Subject: PA-2022-099 1855 S. Norfolk St., SUP + SPAR + SDPA  
1885 S. Norfolk St., APN 035-383-200

This letter is a follow up to your Planning Application submittal of January 3, 2022. The City's Development Review Board has reviewed your application and found that there are a number of issues that must be addressed. At this time your application is incomplete. Prior to continuing the processing of your application, the information on the attached list must be provided. It is always difficult to identify all issues at this stage of your application, and there may be additional information requested by the Development Review Board, Planning Commission, or City Council during the review process.

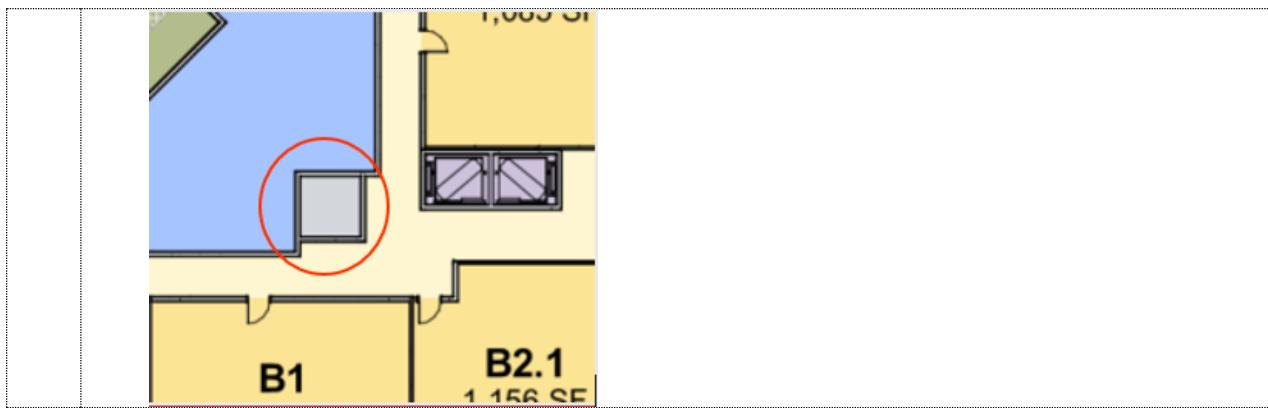
- All existing and proposed fencing or retaining walls including height and location (see Zoning Code § 27.84.010). Elevations and sections are required for some fencing.
  - Please dimension and label all proposed fencing and retaining walls on the site plan. Please also provide elevations and sections for each type of fence/wall.
  - Please indicate what the highlighted box represents.

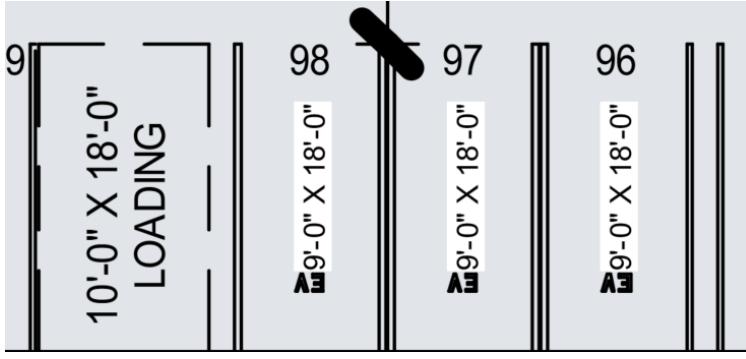
- See the *Design Concerns* section below for additional information.
- Please identify the proposed scope of work for the existing and proposed dock.
